Mask Set Errata for Mask 2L31N

This mask set errata applies to the mask 2L31N for these products:

- MC68HC908EY16
 - MC68HC908EY8
-

Figure 1. Maximum Time for Other Execution

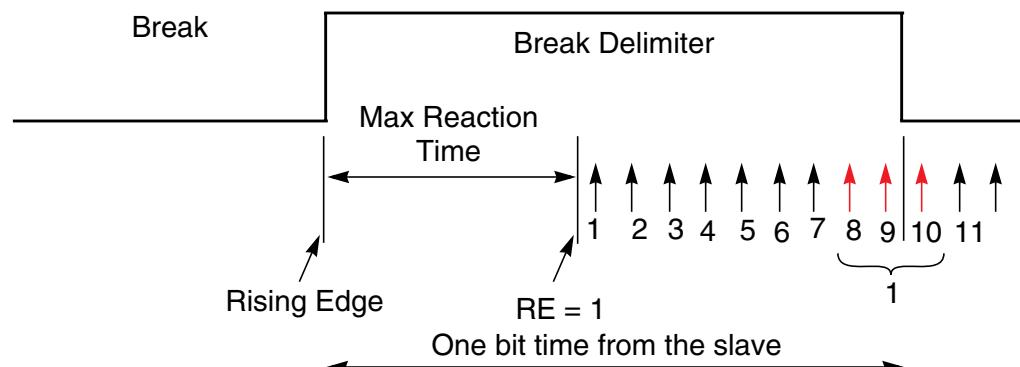
The time between when the rising edge actually appears on the receive pin and when the receiver is switched back on is finite and is governed by the timing of the falling edge of the delimiter. The receiver must be switched back on no later than 9/16th of a bit time before the end of the delimiter. See [Figure 1](#).

From Figure 1, we also see that the “Maximum Reaction Time” is 7/16th slave bit-time.

The Maximum Reaction Time for this example system is $7/16 \times (44.5 \mu s) = 19.47 \mu s$.

From the instant the rising edge appears on the receive pin (detected via the arbiter AFIN bit or a timer interrupt), the software has to switch the receiver OFF and back ON within 19.47 μ s.

Because ground shift in the physical layer might also affect the timing of the falling edge of the START bit of the 0x55 synch byte (i.e., the end of the delimiter), best design practices suggest that the switching of the receiver should be done as quickly as possible after the rising edge is detected. The maximum reaction time calculated above should be treated as a guideline only.
